## TOPIC 4, KEY ISSUE 1 – DENSITY CONTROLS

### 1. SUBMISSION POINTS

Figure 1: Diagram illustrating maximum height for a Gable roof

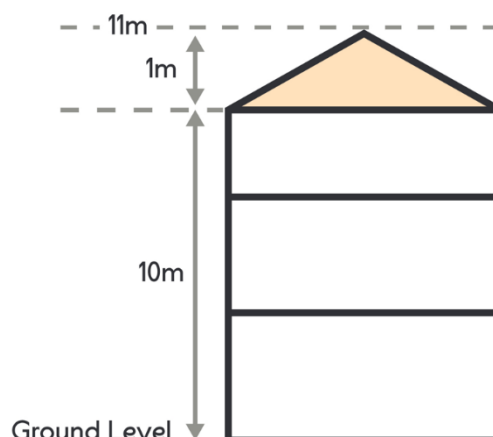
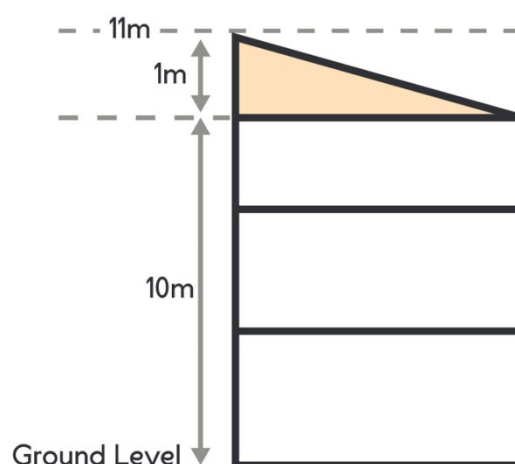
134.19	McFlynn Surveying and Planning	Performance Standard MRZ-S1 Height	Oppose	Revert to the existing, and appropriate, maximum building height of 8m.	Reject
FS031.3	Surveying the Bay, A Taylor	Submission point 134.19	Support in part	Allow submission but suggest a height of 9m might be appropriate.	Reject

- 2.22 By imposing a lower building height maximum, along with the imposition of the other Medium Density Residential Zone standards, it is considered that the height of the building will blend in with adjacent General Residential environments effectively. The recommended standard will read as follows:

- a. Buildings and structures (excluding fences and standalone walls) must not exceed a height above ground level of ~~44m~~ **10m**
  - b. Except that buildings that have a pitched or gable roof may have a maximum height above ground level of up to ~~42m~~ **11m** (see figure 1 and 2 below)
